ADDENDUM NO. THREE (3)

IFB NO. 2024-282

CONSTRUCTION, EMERGENCY GENERATOR FUELING SYSTEM REPLACEMENT

DATE: JUNE 17, 2024

CENTRAL PLANT GENERATOR FUELING SYSTEM
COLLIN COUNTY JUSTICE CENTER
EMERGENCY GENERATOR FUELING SYSTEMS
4300 COMMUNITY AVENUE
MCKINNEY, TEXAS 75071

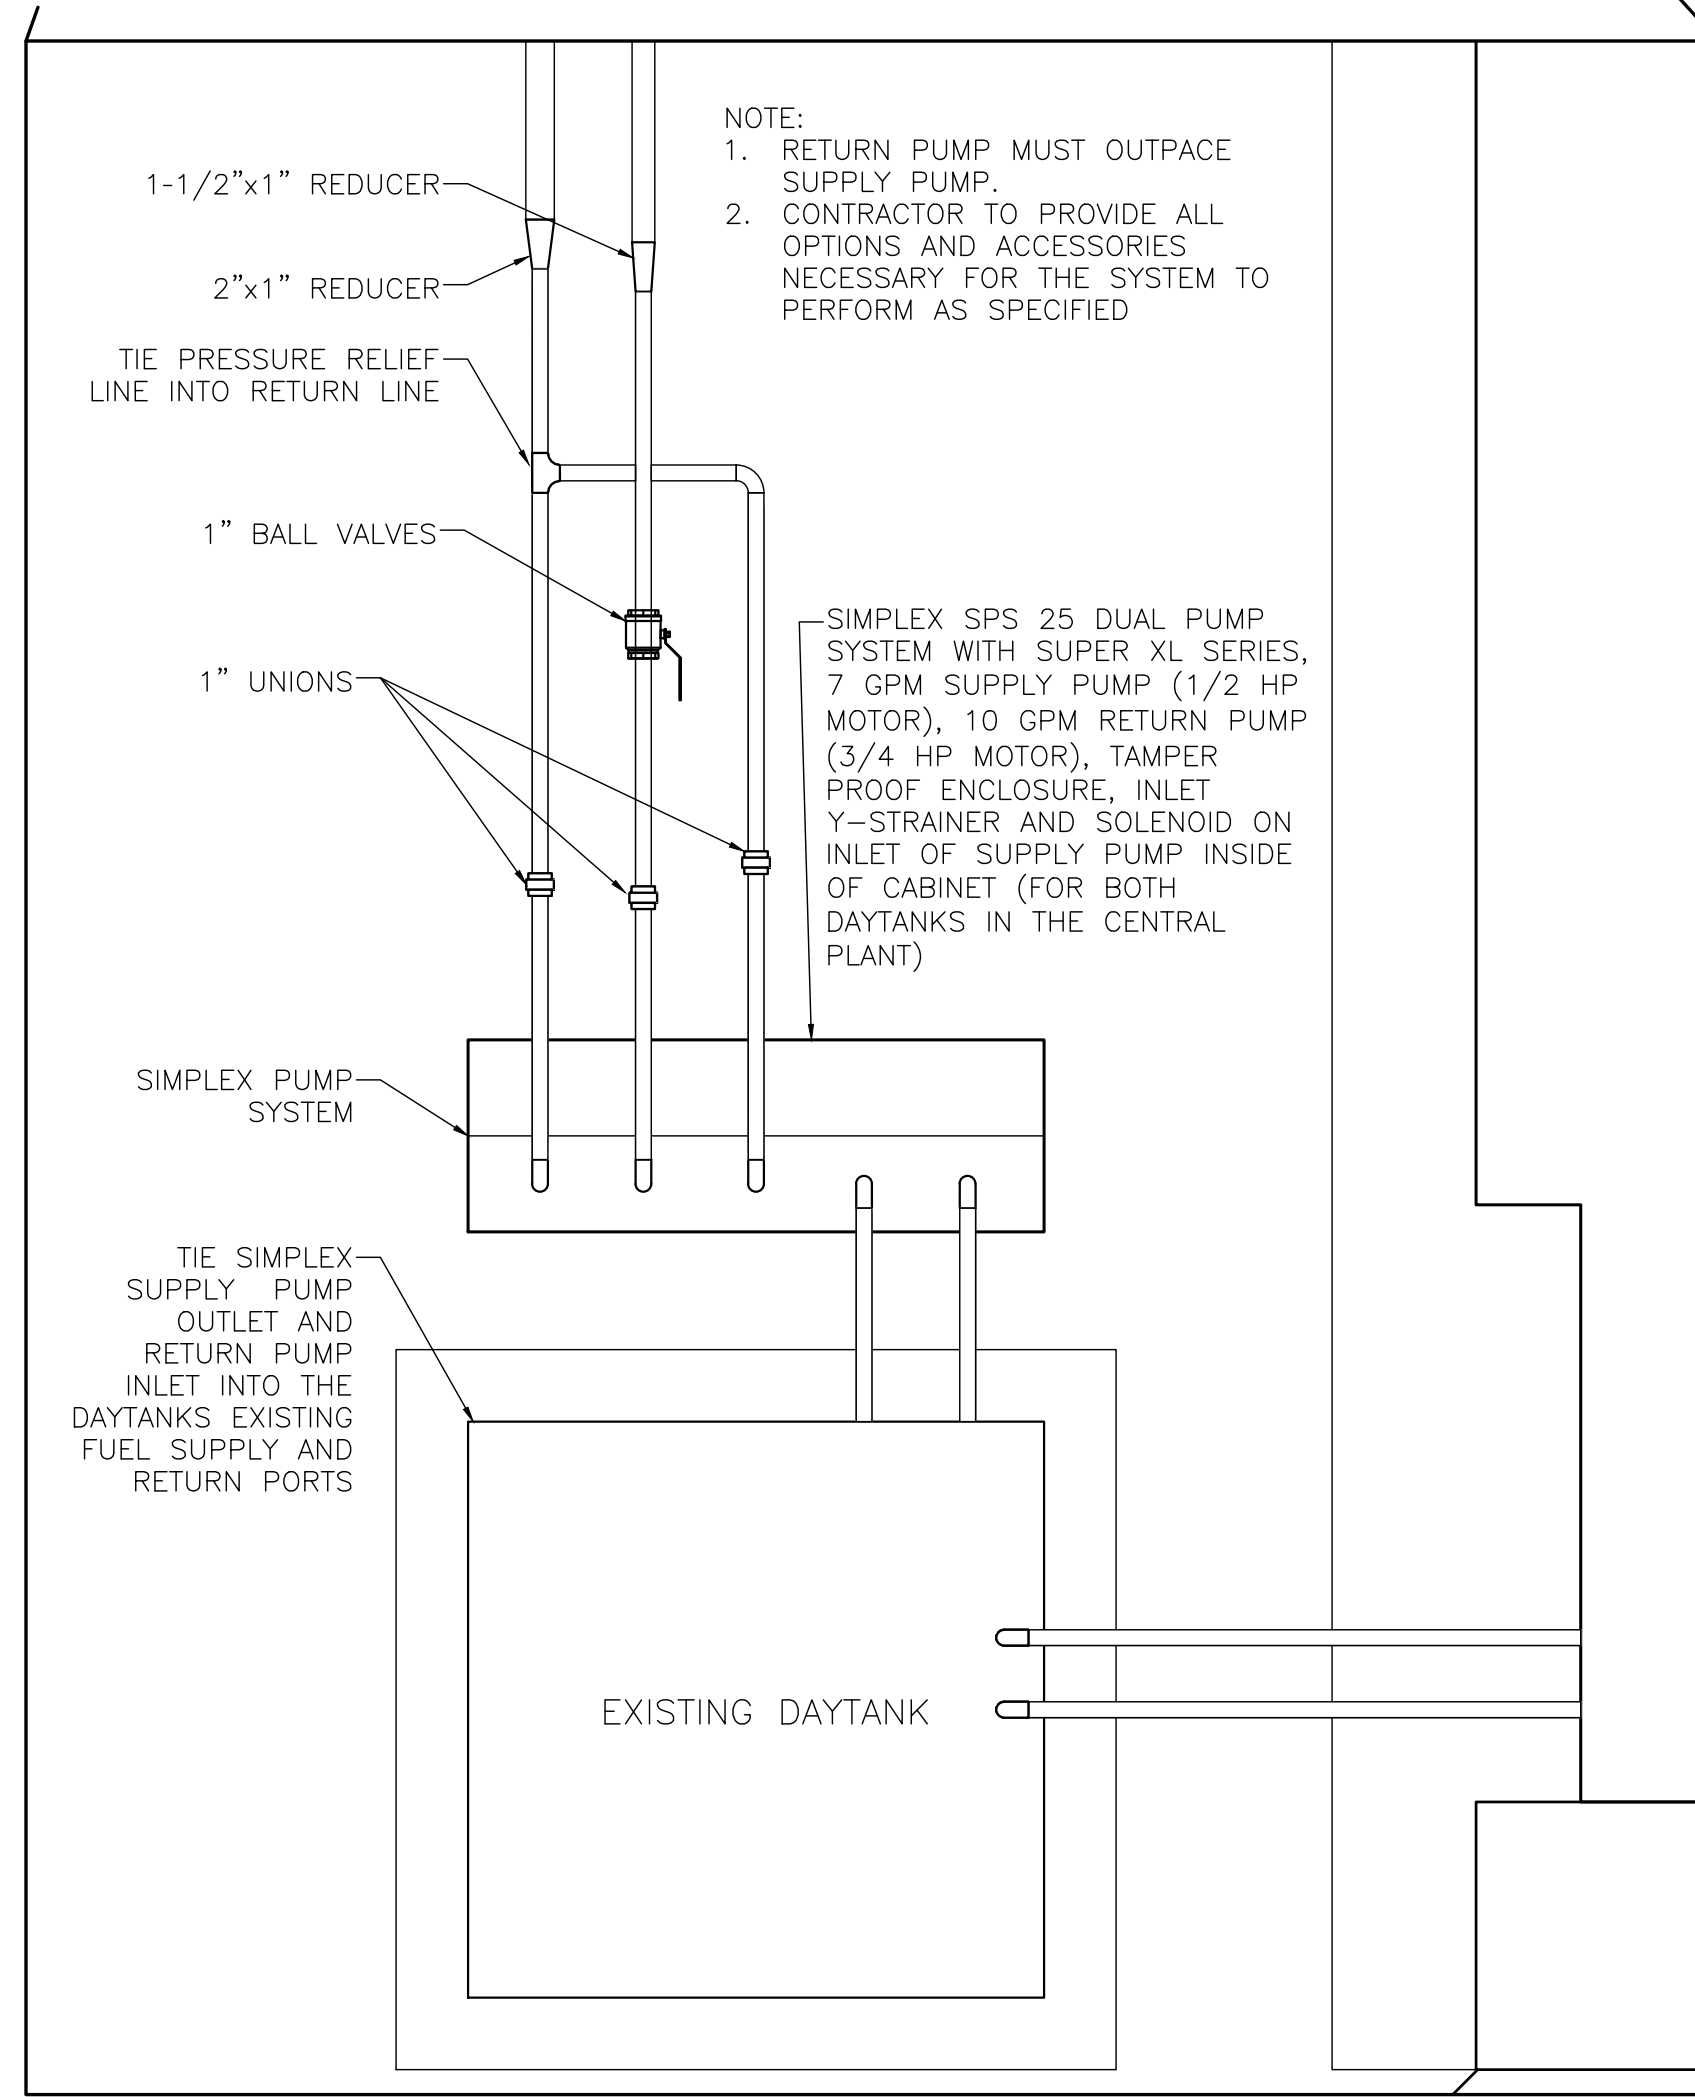
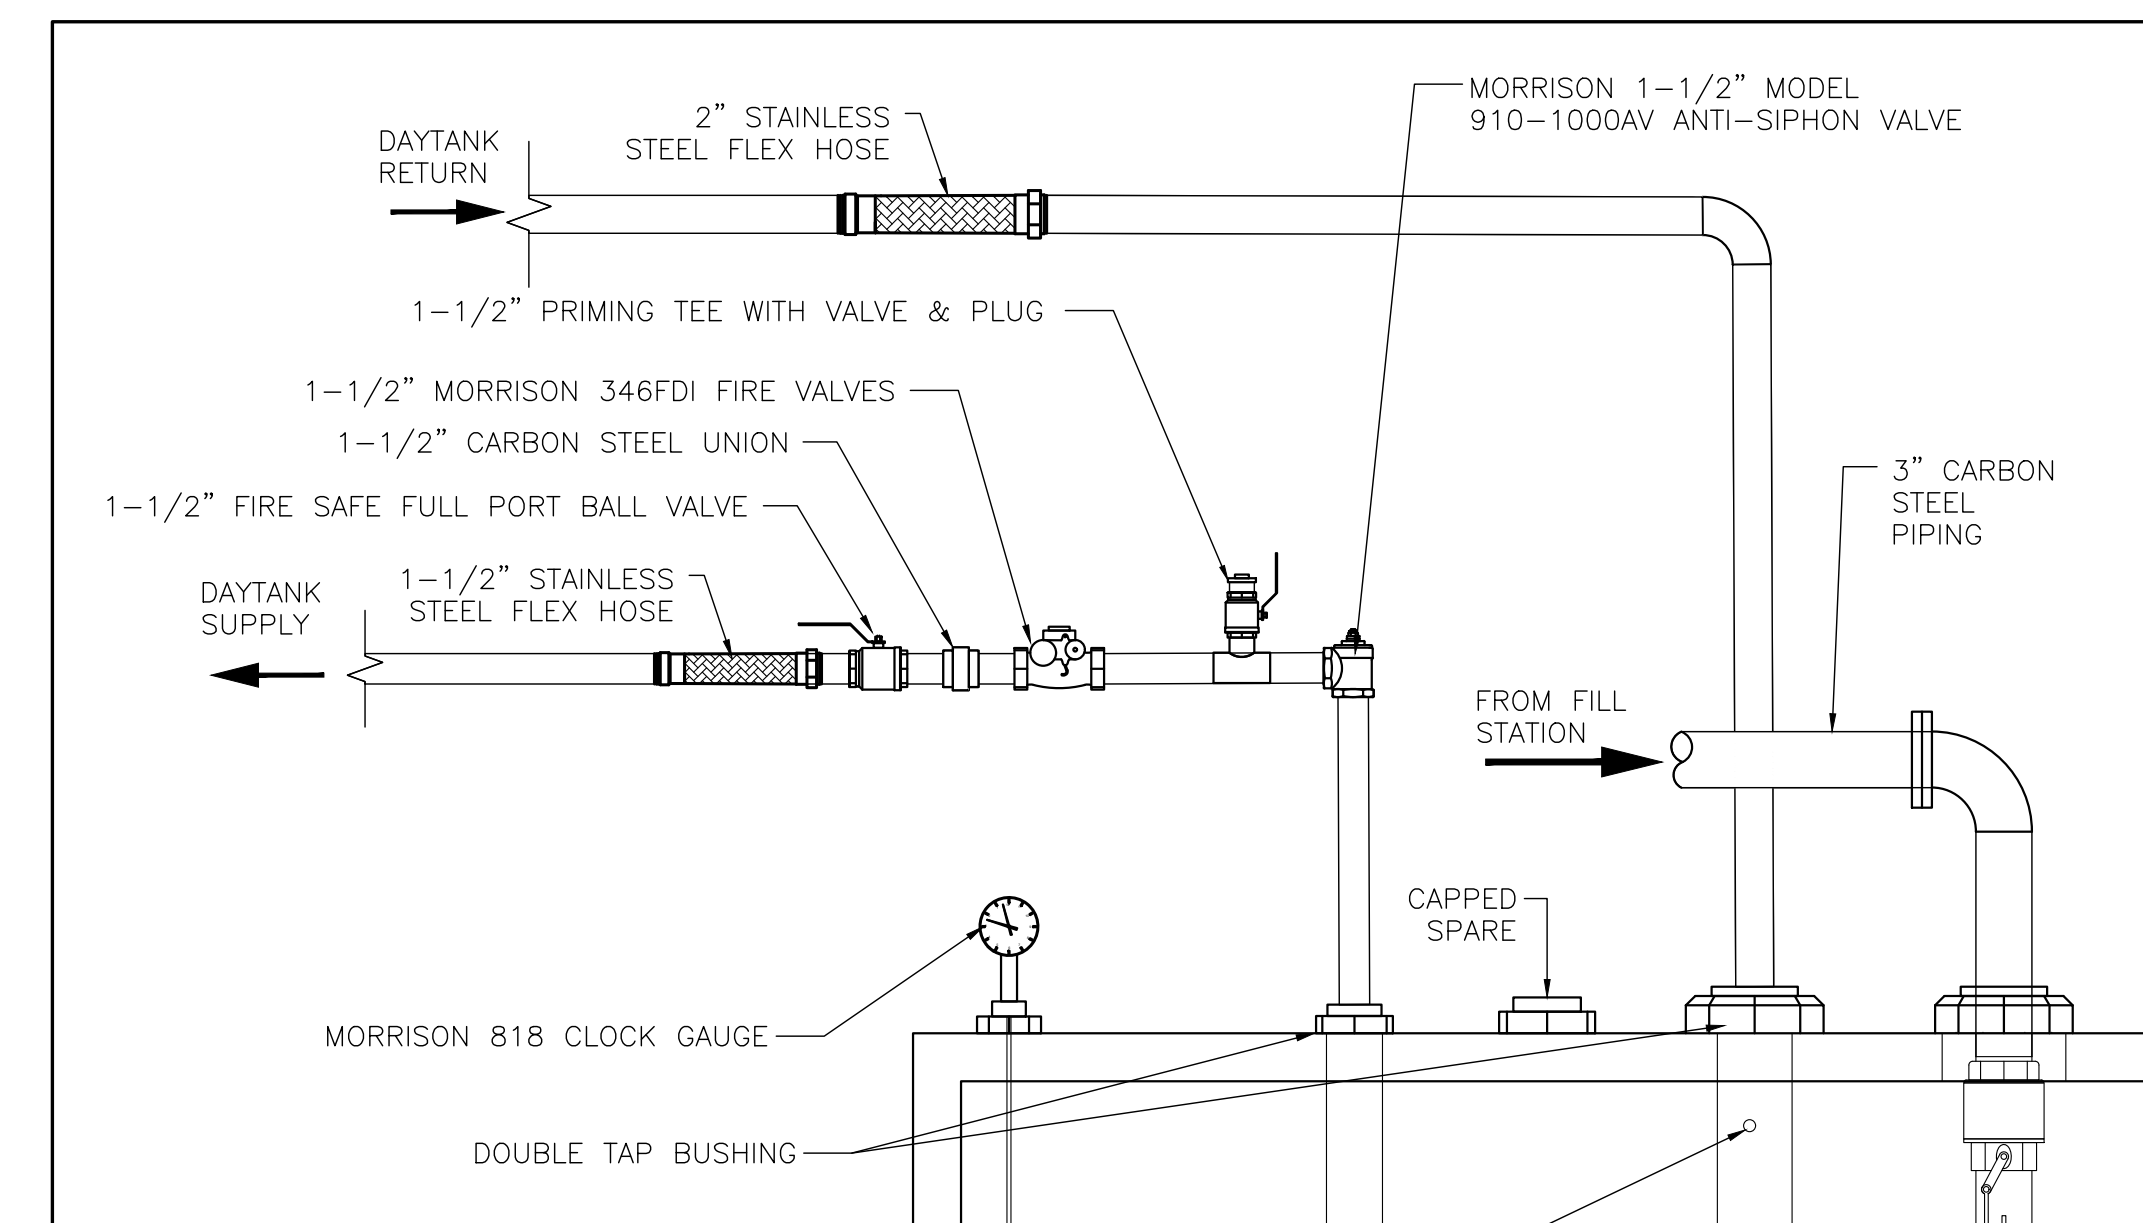
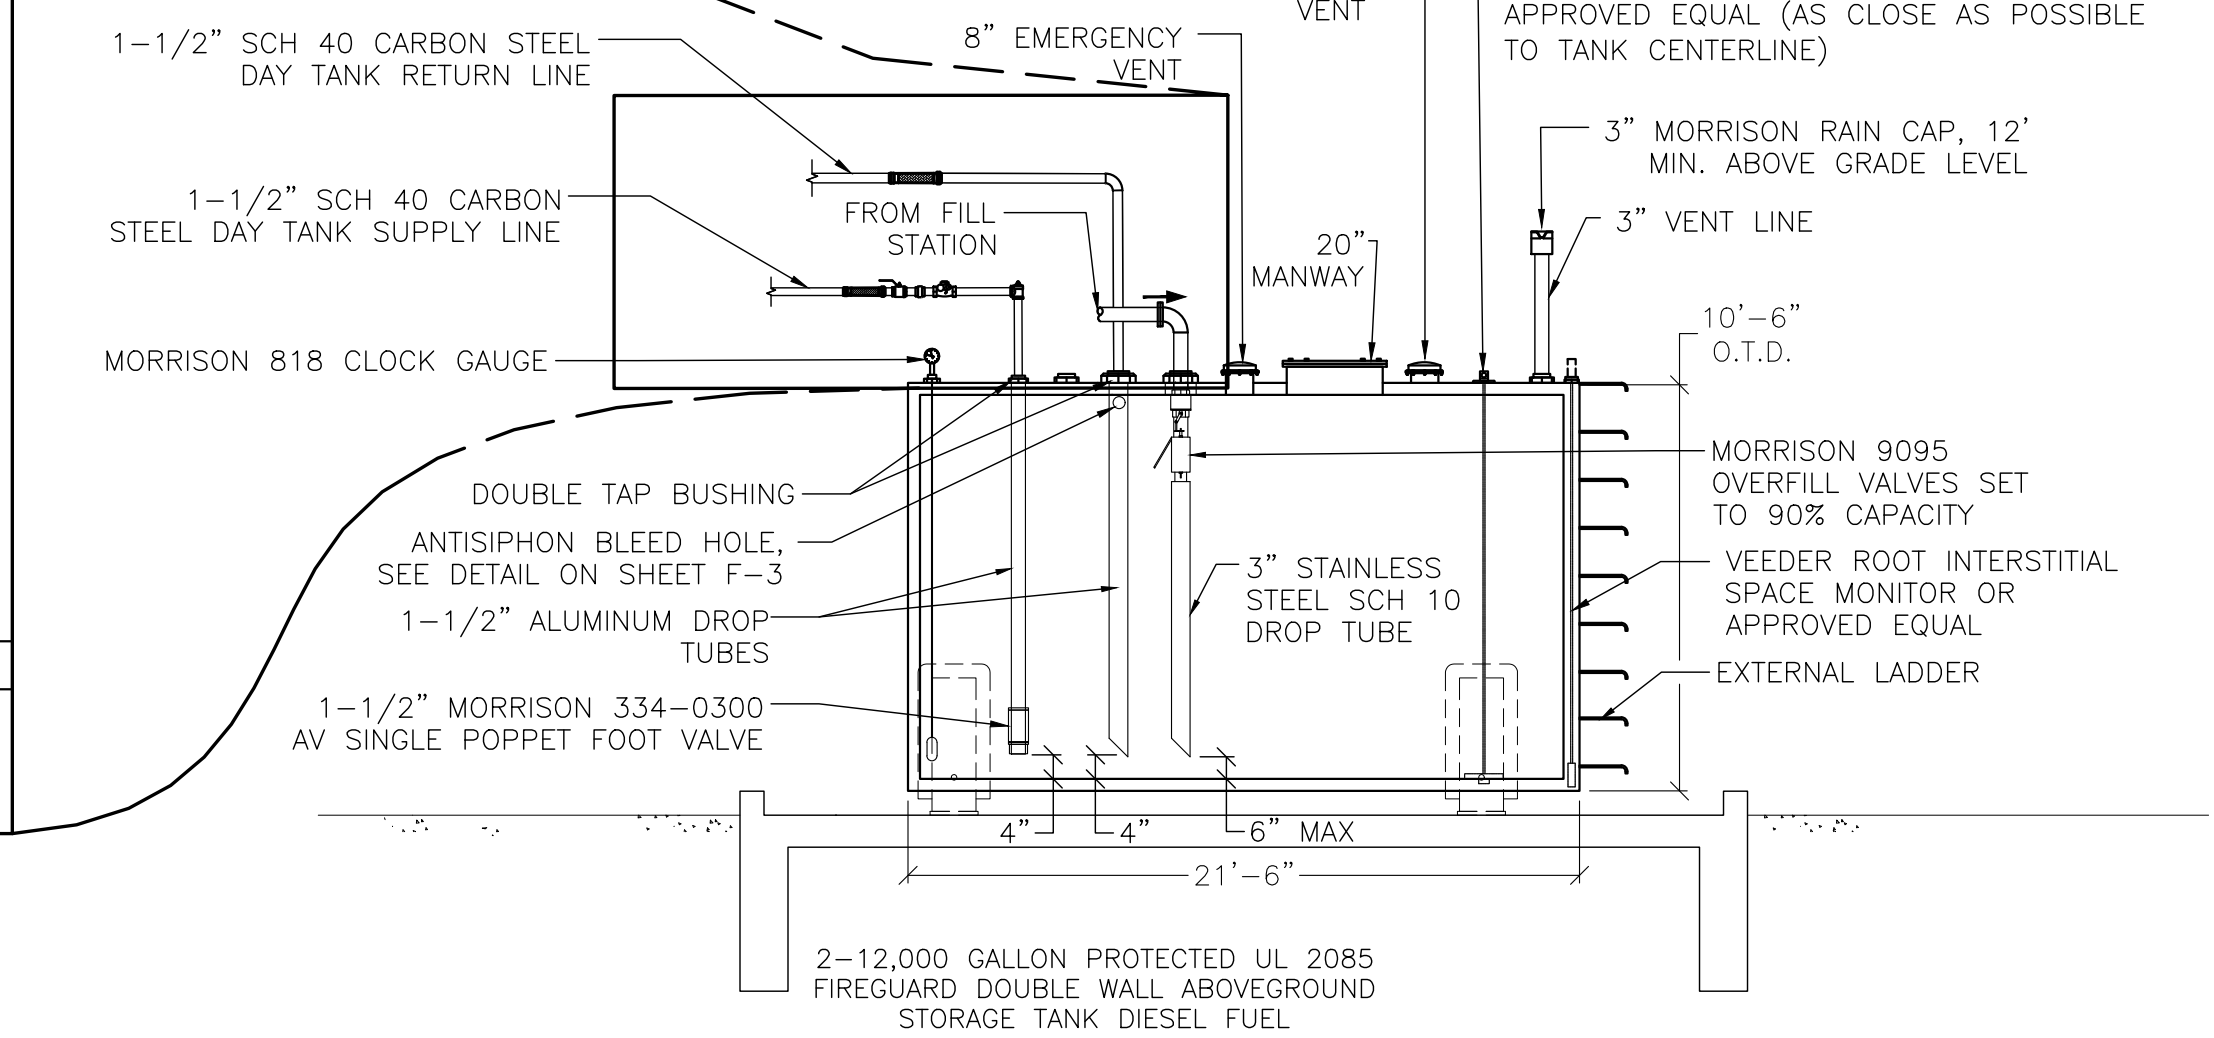
DESIGNED BY	CDS		
DRAWN BY	DAG		
CHECKED BY	RNB		
REVIEWED BY	RNB		
DATE	1-29-2024		
NO	DATE	VALVE CHANGES, PRIMING TEE ADDED, RETURN LINE SEPARATED REVISION	CDSm BY
1	2024-6-5

Question: Drawing 6 of 16 detail 3/F-2 and 7 of 16 detail 10/F-3 shows no 9095 Overfill valve on the return line. Drawing 8 of 16 detail 6/F-3 shows a 9095 overfill valve on the return line. Should there be a 9095 on all return lines or leave as drawn?

Answer: No valves on return lines. See Addendum 3 for revised drawings.
